Access Compliance Report

Public Rights-of-Way

(Pedestrian Signals)

Intersection ID: N/A	Main Street:	Cross Street: N/A	Location: N/A
ADA ID: 79E24EBFACE7	Signal Type: Two Push Buttons-APS	Overall Compliance: No	Severity Score: BTN 1:N/A BTN 2: N/A No BTN: N/A
Codes/Mitigation Info/Possible Solution		Field Measurements/Component Compliance

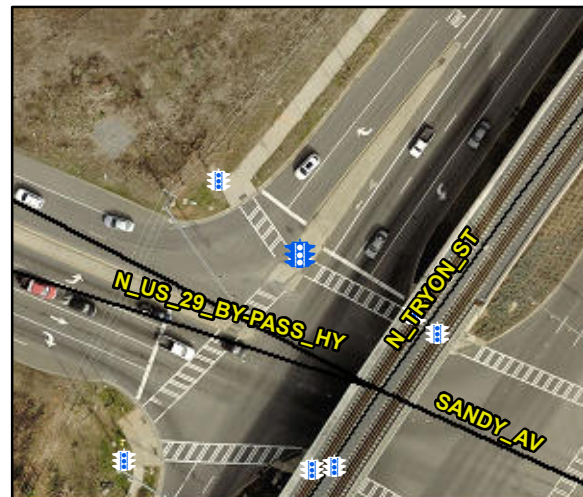
Surveyor Notes: TEXT HT 5/16, B2 DIR OF XING SOUTHEAST & NORTHWEST

PROW/ADA: R410.6, R209.1, TMUTCD 4e.08, R404.2, R404.3, R404.7.3, , R406.2

Possible Solutions: Replace Signal Push Button With APS Button on New Post. Remove & Replace Sign.
